ADDENDUM

NO. 01

PROJECT NAME: Littleton Springs Elementary School

ADDENDUM DATE: March 13, 2026

1 E2.00 ELECTRICAL SITE POWER PLAN
1" = 40'-0"

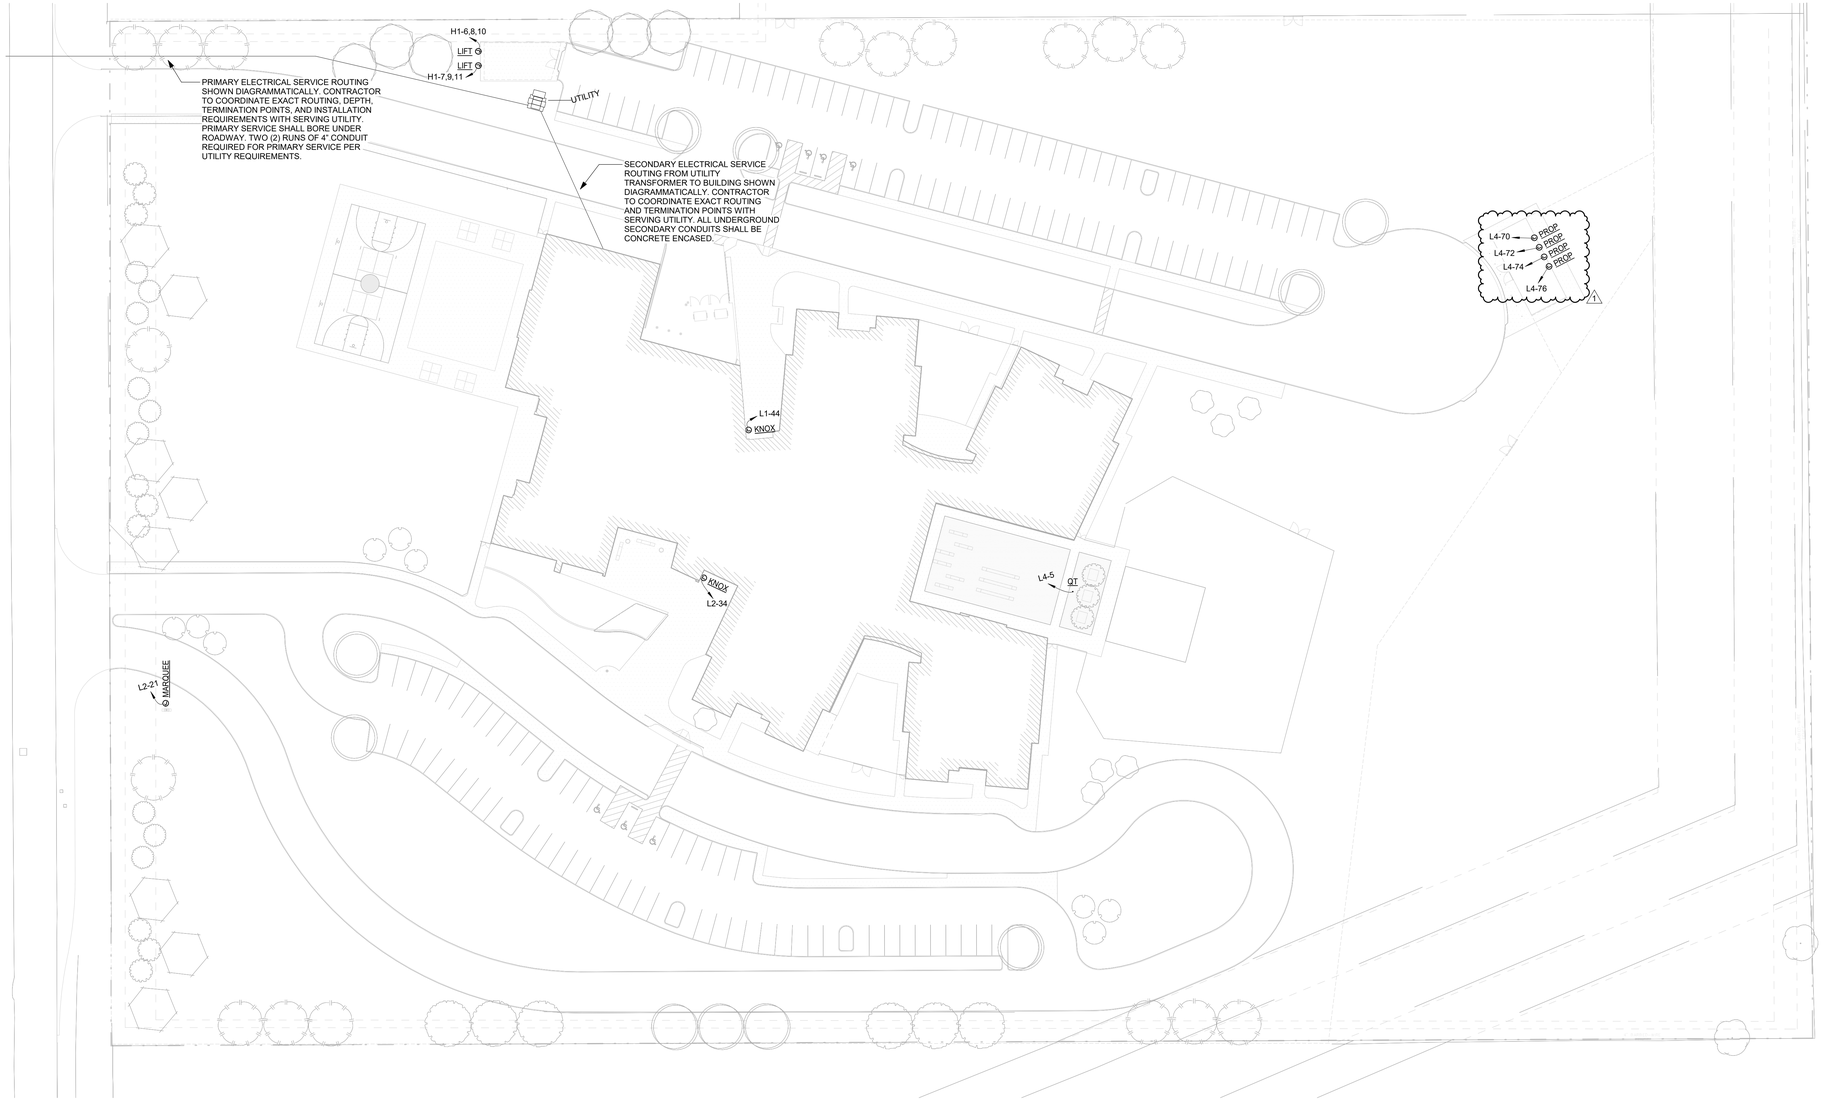
P2ADD 01, Elec Item 1: To the Drawings, Sheet E2.00, "ELECTRICAL POWER SITE PLAN,"
Replace sheet in its entirety as issued per this Addendum, Revisions as follows:
1) Added power for propane tank accessories.

1 POWER PLAN - LEVEL 1 - AREA A
1/8" = 1'-0"

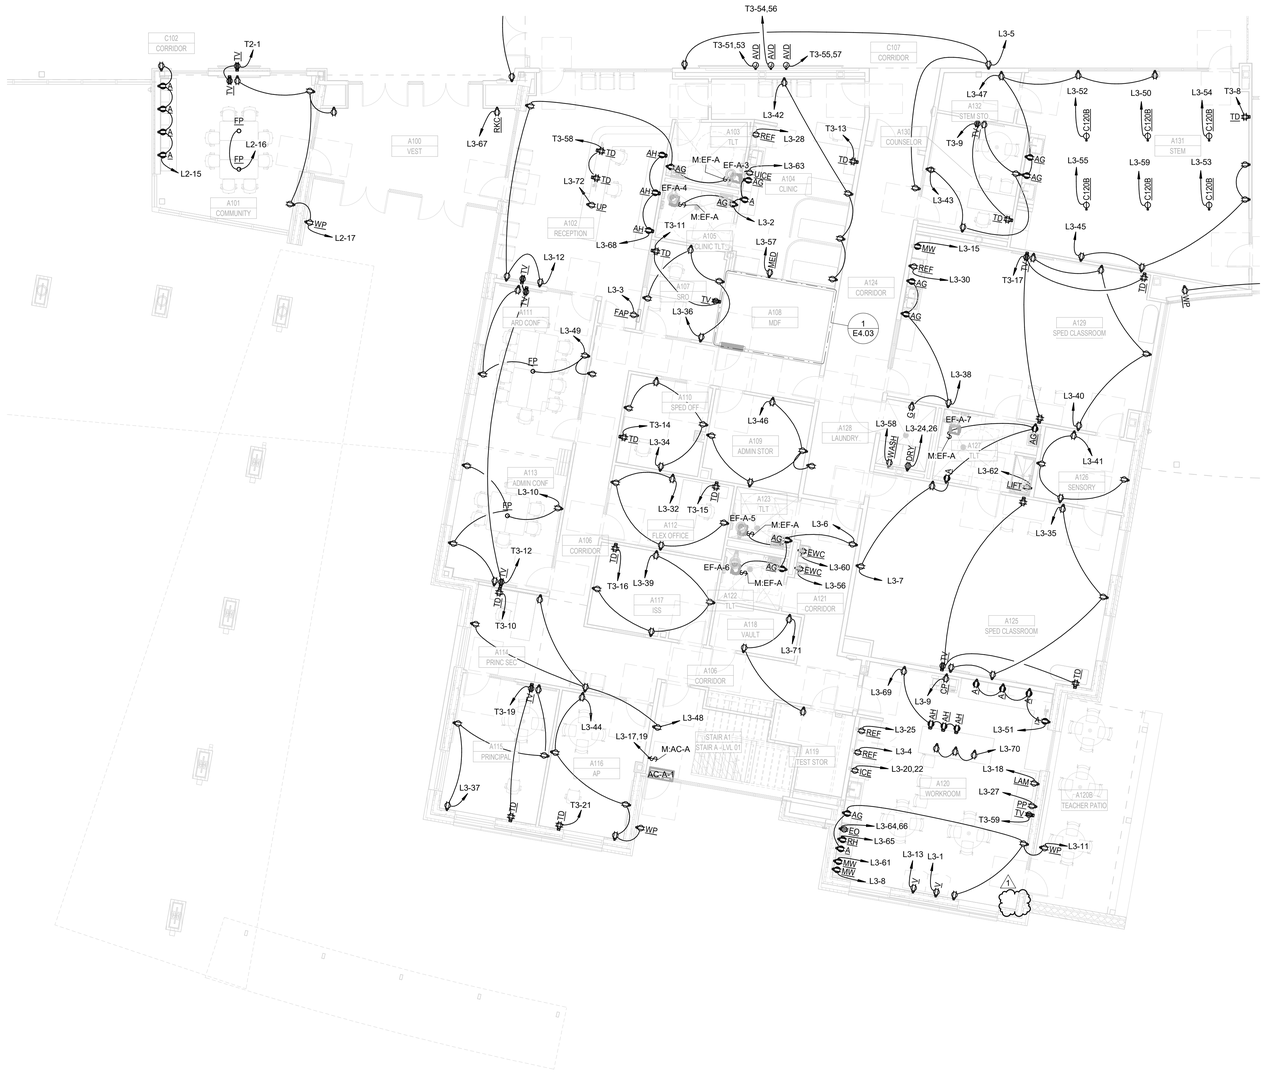
P2ADD 01, Elec Item 2: To the Drawings, Sheet E2.01, "POWER PLAN – LEVEL 1 – AREA A,"
Replace sheet in its entirety as issued per this Addendum, Revisions as follows:
1) Removed air curtain power for A120 WORKROOM.
